**PLANNING APPROVAL, PUD &  
SUBDIVISION STAFF REPORT****Date: December 18, 2003****DEVELOPMENT NAME**

University Square

University Square Subdivision

Multiple Buildings on Multiple Lots with Shared Parking and Access Between Building Sites. Climate Controlled Personal Storage Facility on Lot 2.

## SITE PLAN

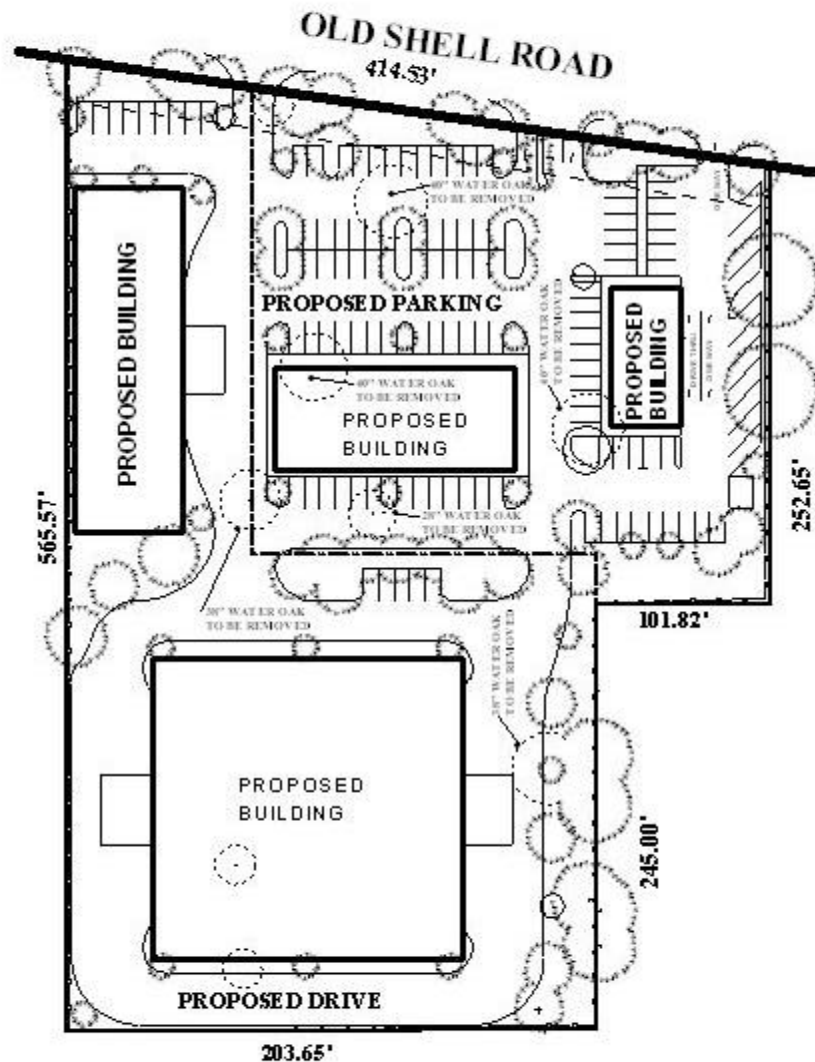
Driveway number, sizes, location and design to be approved by Traffic Engineering and conform to AASHTO standards. Developer to pay for signal modifications. Modification to be to City standards.

Urban Forestry would like to request, per previous PUD approval, that the 38" Live Oak be given preservation status (Any work around, including trimming or removal of this tree, requires approval from the Mobile Planning Commission.) All work under the canopy is to be permitted and coordinated with Urban Forestry, removal to be permitted by Urban Forestry only in the case of disease or impending danger. The 24" Water Oak located in the main entrance drive requires a permit from the Mobile Tree Commission for removal.

**Planning Approval:** based on the preceding, it is recommended that this application be approved subject to the following conditions: 1) completion of the rezoning and subdivision processes; 2) size, location and design of curb cuts to be approved by the Traffic Engineering Department, unused existing curb cuts to be closed – including installation of landscaping and curbing; 3) the 38" Live Oak on the northwest side of Lot 2 be given preservation status, all work done under the drip line of the tree is to be coordinated with Urban Forestry. Removal to be permitted by Urban Forestry only in the case of disease or impending danger; 5) full compliance with all municipal codes and ordinances, including but not limited to landscaping and tree plantings and the provision of sidewalks.

**Planned Unit Development:** based on the preceding, it is recommended that this application be approved subject to the following conditions: 1) completion of the rezoning and subdivision processes; 2) size, location and design of curb cuts to be approved by the Traffic Engineering Department, unused existing curb cuts to be

closed – including installation of landscaping and curbing; 3) the 38” Live Oak on the northwest side of Lot 2 be given preservation status, all work done under the drip line of the tree is to be coordinated with Urban Forestry. Removal to be permitted by Urban Forestry only in the case of disease or impending danger. The 24” Water Oak located in the main entrance drive requires a permit from the Mobile Tree Commission for removal; 5) full compliance with all municipal codes and ordinances, including but not limited to landscaping and tree plantings and the provision of sidewalks.

**Subdivision:** based on the preceding, it is recommended that this plat be granted Tentative Approval subject to the following conditions: 1) placement of a note on the final plat stating that size, location and design of curb cuts to be approved by the Traffic Engineering Department, unused existing curb cuts to be closed – including installation of landscaping and curbing; and 2) placement of a note on the final plat stating that the 38” Live Oak on the northwest side of Lot 2 be given preservation status, all work done under the drip line of the tree is to be coordinated with Urban Forestry. Removal to be permitted by Urban Forestry only in the case of disease or impending danger. The 24” Water Oak located in the main entrance drive requires a permit from the Mobile Tree Commission for removal.
